PCN – Process Change Notification

Change:	WA.500W.301151
Date:	2017/07/04
Author	Haley Tsai

Model#	Part Number	Changes
WA.500W Stingray Glassmount 2.4/5.0GHz RP- SMA(M)ST 3M RG174- waterproof	WA.500W.301151	<ol style="list-style-type: none"> 1. Add dimension from heat shrink tube to WEEE tube. 2. Amend connector tolerance. 3. Amend housing dimensions and tolerances. 4. Change 2.4/5 GHz label to 2.4/5.8 GHz label. 5. Amend WEEE label to WEEE tube. 6. Amend housing material. 7. Amend label's orientation.

Illustration of Change

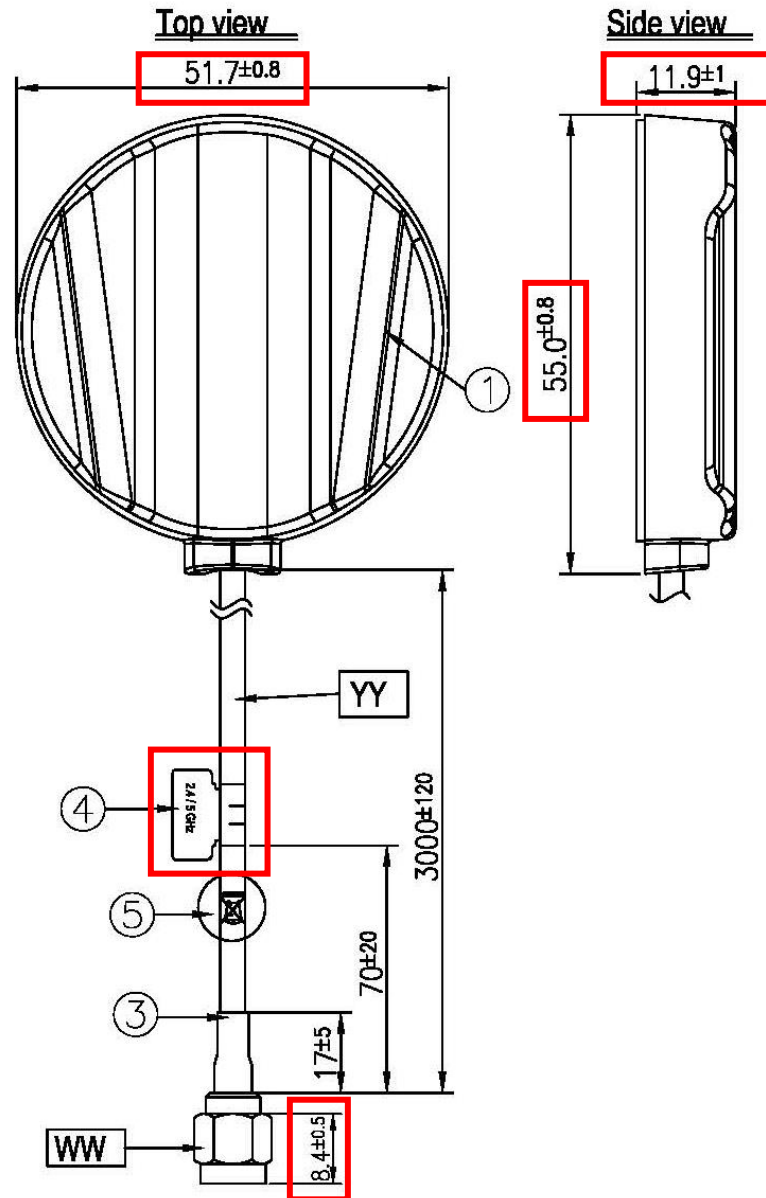
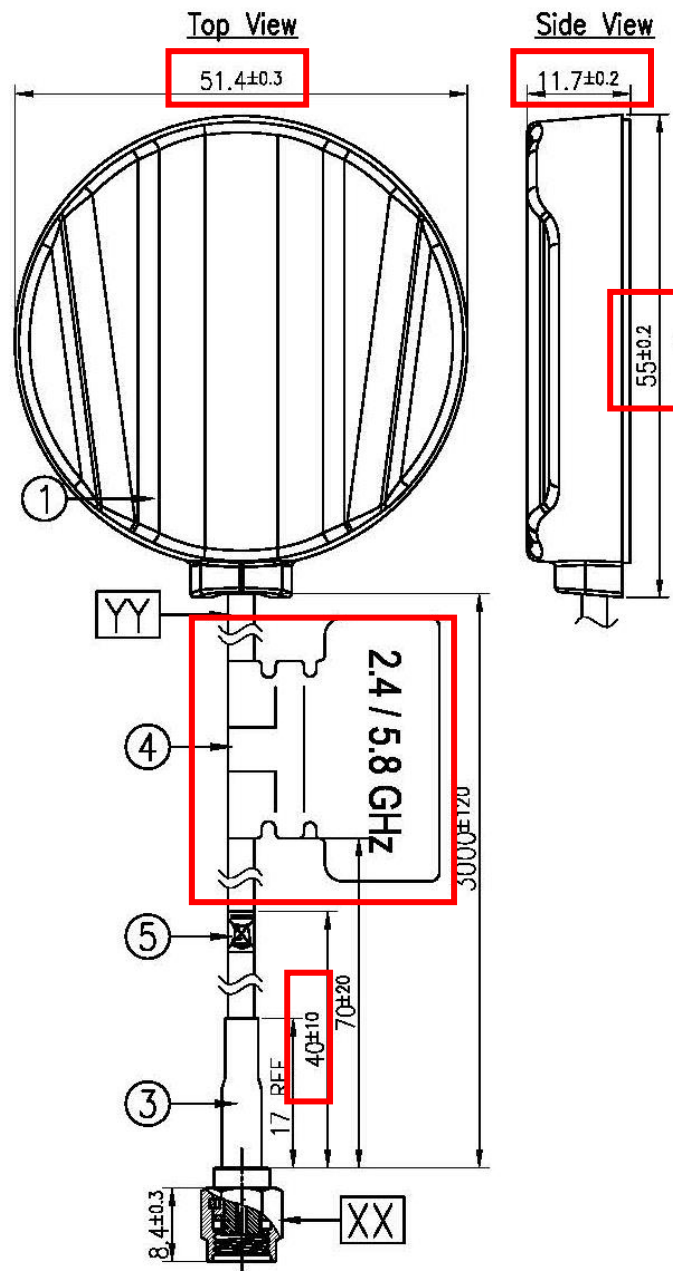
1. Add dimension from heat shrink tube to WEEE tube.
2. Amend connector tolerance.
3. Amend housing dimensions and tolerances.
4. Change 2.4/5 GHz label to 2.4/5.8 GHz label.
5. Amend WEEE label to WEEE tube.
6. Amend housing material.
7. Amend label's orientation.
